**PITTSBURG UNIFIED SCHOOL DISTRICT
PUSD MARTIN LUTHER KING JR JUNIOR HIGH SCHOOL
RUNNING TRACK AND FIELD ALTERATIONS**

**BID ADDENDUM NO. 2
November 17, 2025**

PROJECT: **Martin Luther King Jr Junior High School Running Track & Field Alterations**
2012 Carion Court, Pittsburg, CA 94565

DRAWING TITLE: LIMITS OF WIND SCREENING AT FENCING
REFERENCE DRAWING: A1.02
ISSUED VIA: ADDENDUM 02 (11/14/25)
SCALE: N.T.S.

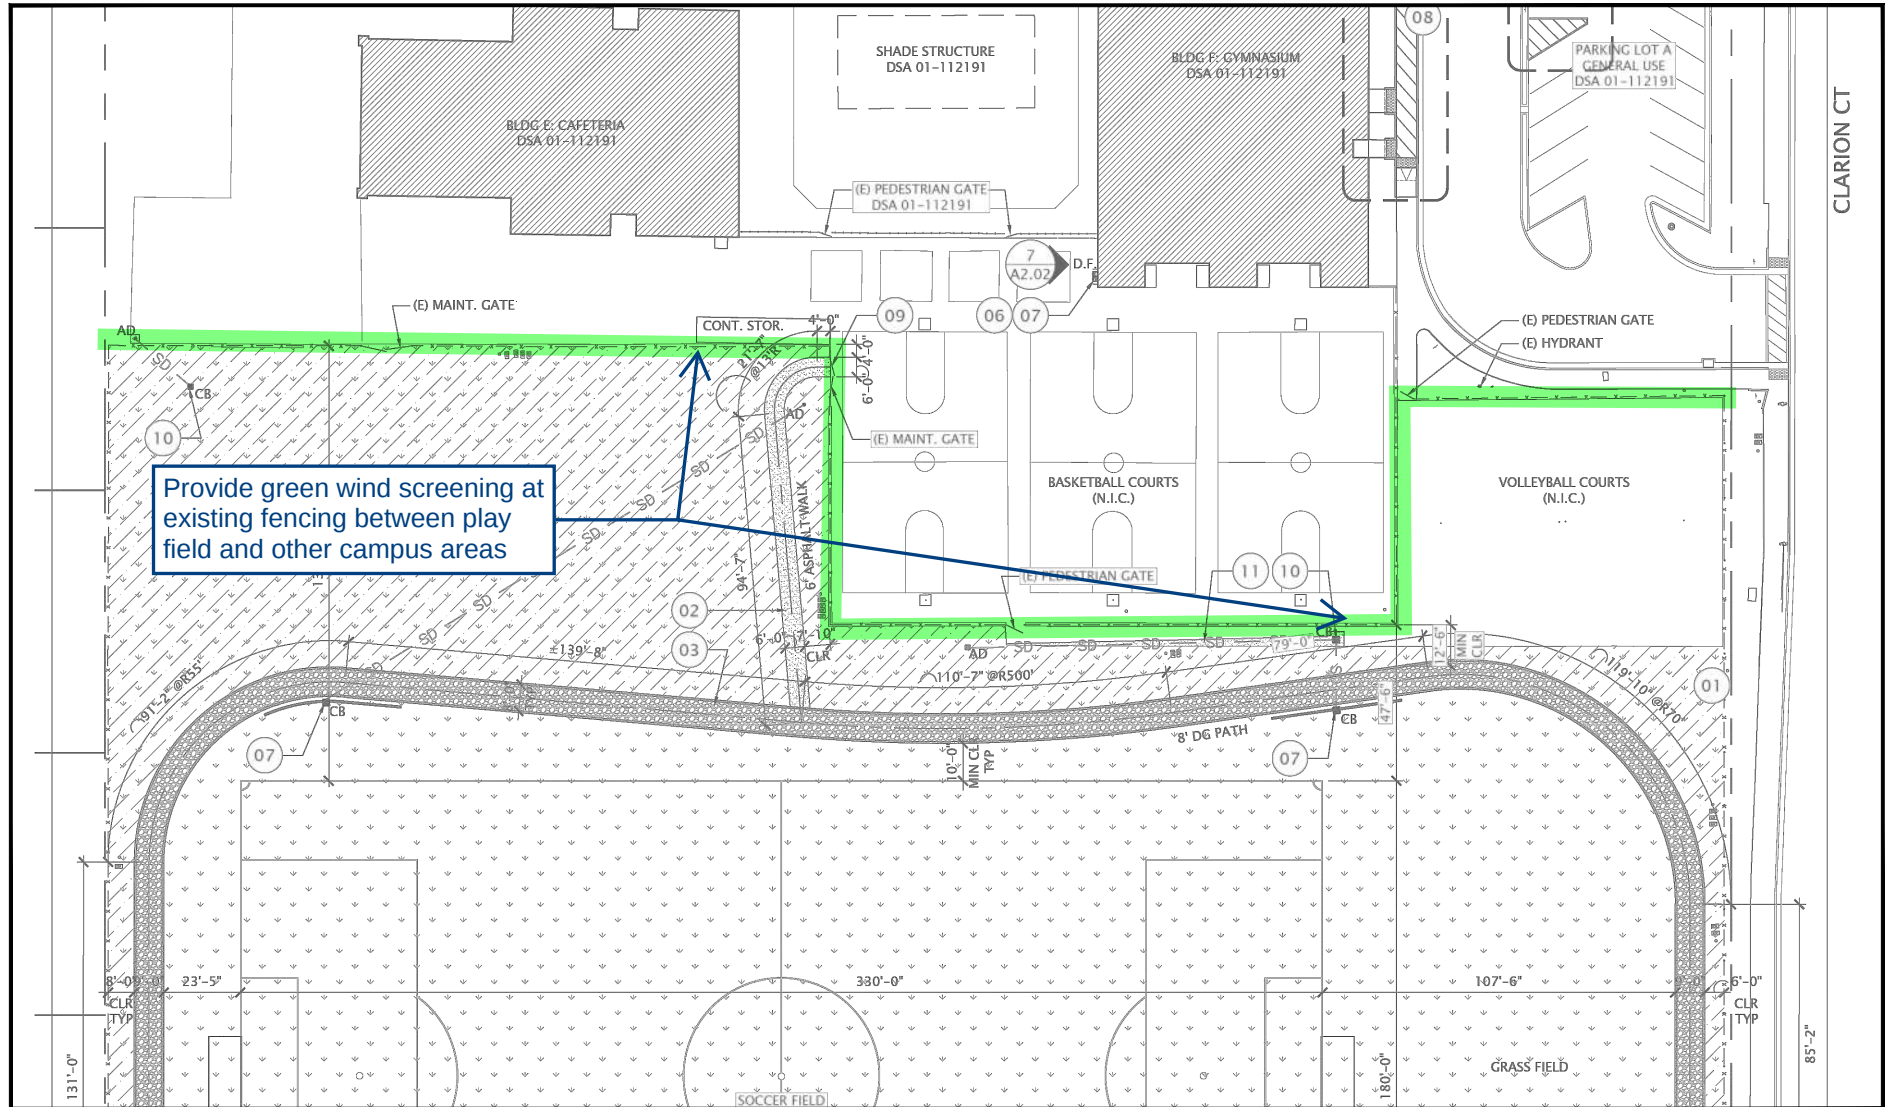
Response: Please see attached CSK-01 for asphalt paving section, and ASK-02 for typical edge condition at landscaping.
- 6. Question/Issue:** Sheet C0.02, "Per notes on C0.02 construction fencing around the site shall have green wind screen. Because we will use the existing fencing as the construction fencing, are we required to place green screen on it?"

Response: Wind screen shall be provided between play field and campus areas per attached ASK-01.
- 7. Question/Issue:** Sheet IR1.0, "The irrigation legend indicates that mainline shall be schedule 40 PVC. However, specification section 32 84 00/ Part 2 indicates that mainline 3" & larger shall be class 200 PVC and 2-1/2" & smaller shall be schedule 40 PVC - (mainline shown on irrigation plan is 3" size). Please clarify"

DRAWING TITLE: ASPHALT PAVING EDGE AT LANDSCAPE
REFERENCE DRAWING: A1.02
ISSUED VIA: ADDENDUM 02 (11/17/25)
SCALE: 2"=1'-0"

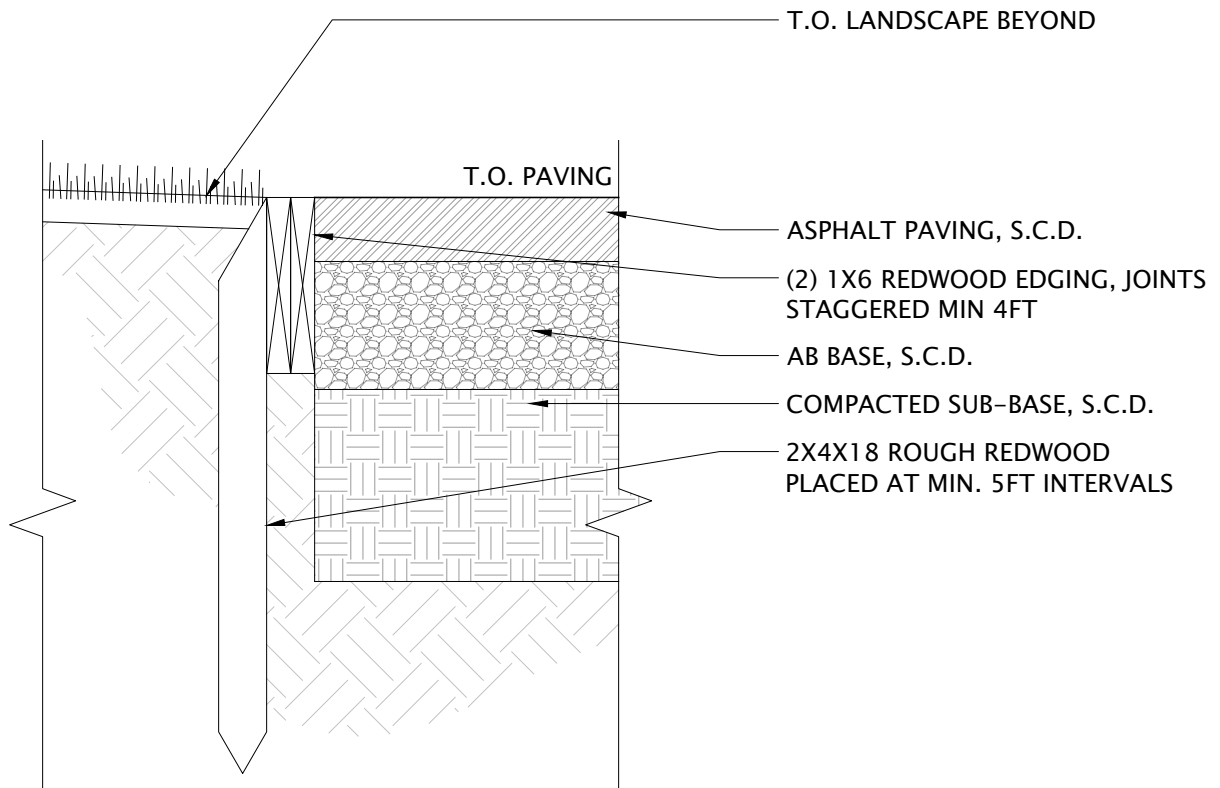
Response: Trench drains shall be installed per manufacturer's recommendations per attached CSK-02 Trench Drain Detail.
- 5. Question/Issue:** Sheet C3.01, "Please provide a detail for the AC Pathway that depicts the sectional depths and edge conditions."

DRAWING TITLE: TRENCH DRAIN DETAIL
REFERENCE DRAWING: C3.01
ISSUED VIA: ADDENDUM 02 (11/14/25)
SCALE: N.T.S.

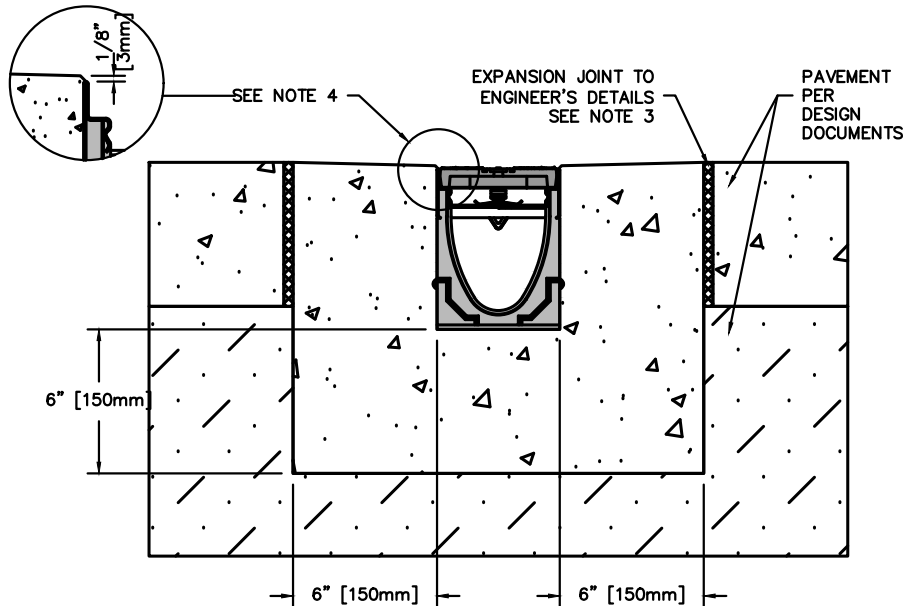
Response: Omit Keynote 07 at existing drinking fountain to be replaced.
- 3. Question/Issue:** Sheet C2.01, "Please provide a detail for the 6" Trench Drains noted and depicted on Sheet C2.01."

Response: Trench drains shall be installed per manufacturer's recommendations per attached CSK-02 Trench Drain Detail.
- 4. Question/Issue:** Sheet C2.01, "Please provide a detail for the 6" Trench Drains noted and depicted on Sheet C2.01."

K100 KLASSIKDRAIN - LOAD CLASS C PROVIDE TRAFFIC RATED AND ADA COMPLIANT GRATE OVER TRENCH DRAIN

DRAWING TITLE: TRENCH DRAIN CALLOUT
REFERENCE DRAWING: C2.01
ISSUED VIA: ADDENDUM 02 (11/14/25)
SCALE: N.T.S.

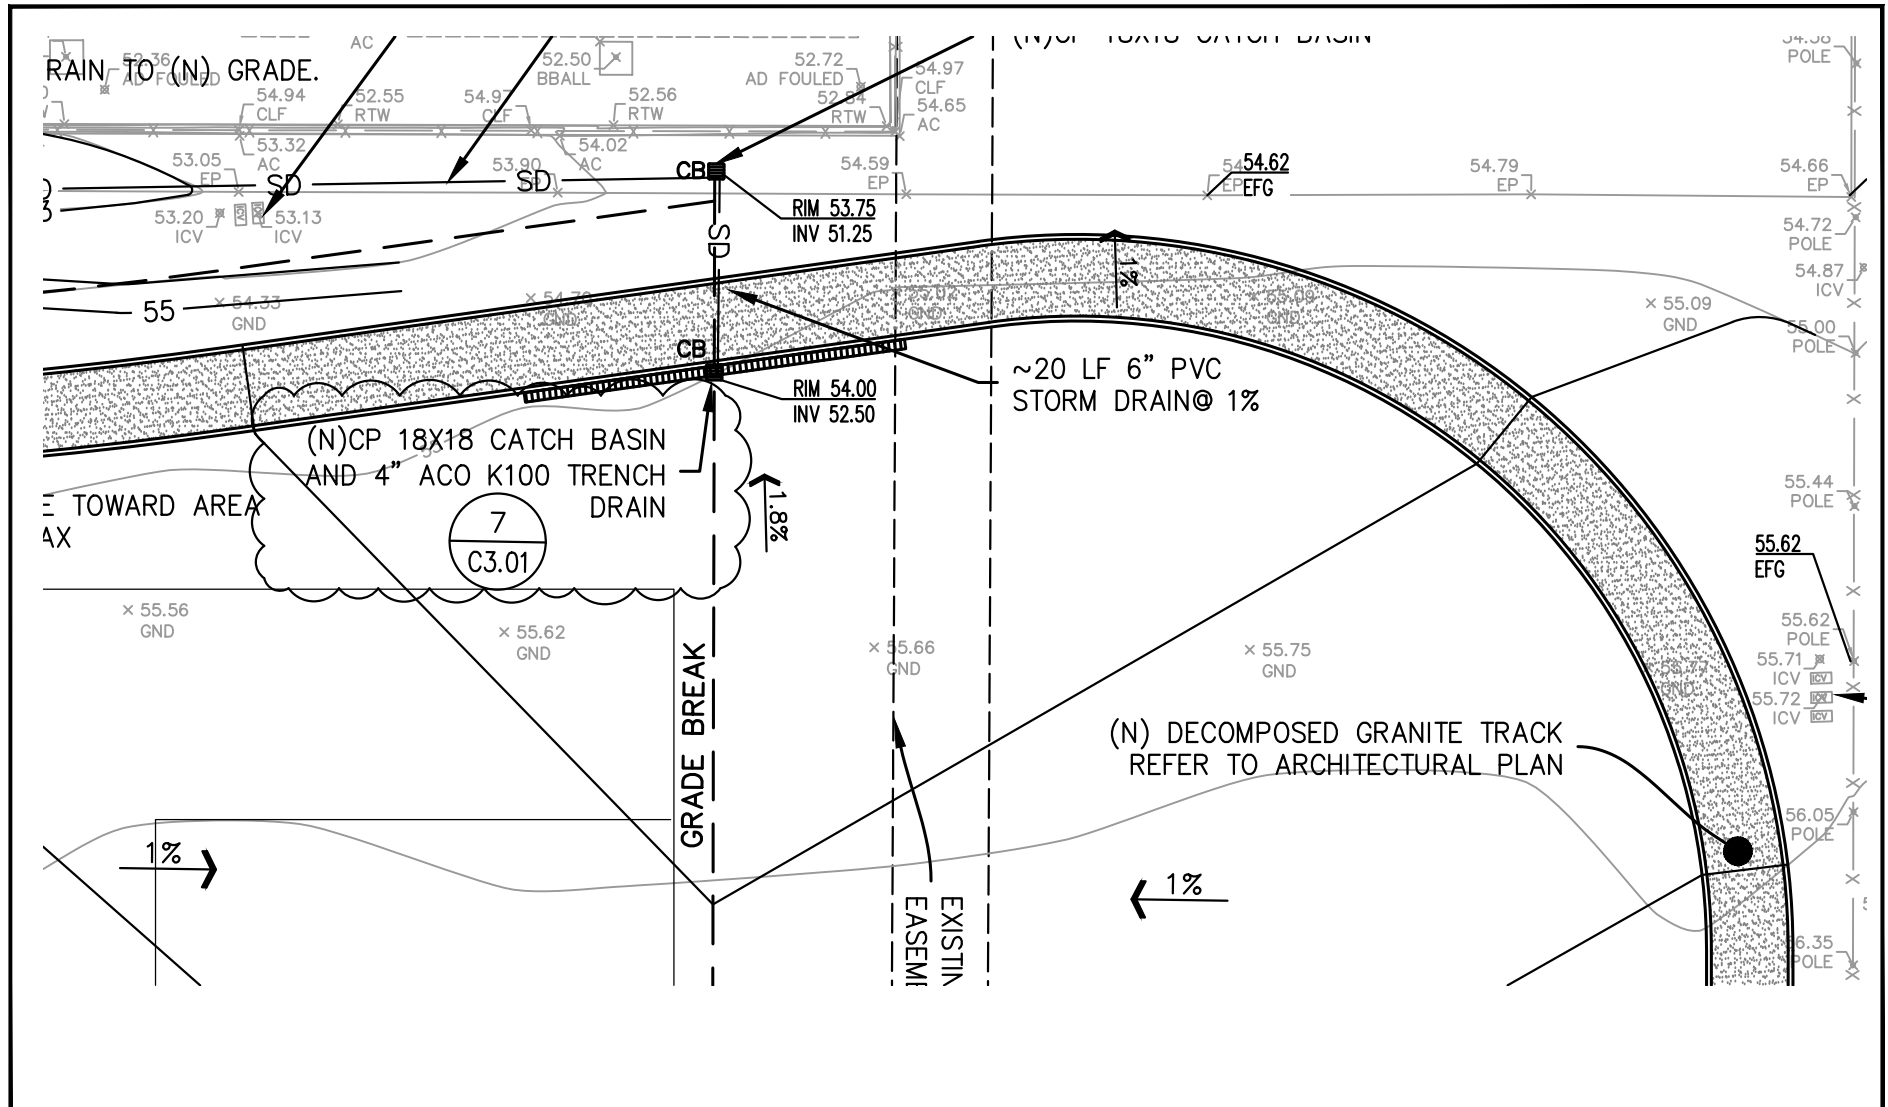
Reference: C2.01
Attachment: CSK-03 & CSK-04
Description: Replace specified "6in trench drain" with "4in ACO K100 trench drain,"
typical of all locations. Contractor shall provide a widened curb per
CSK-04 where trench drains installed along curved walkways.
